ADDENDUM NO. 2

PROJECT 3023, Willow Pass Road Storm Drain Repair Project

SHEET IM-01, SECTION A

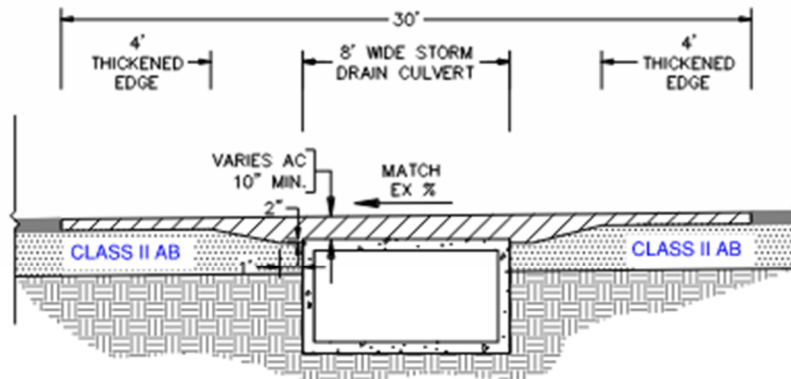
6. CLARIFICATION: Some hatches on the Section Details are not in the legend.
 See the images below for clarification:
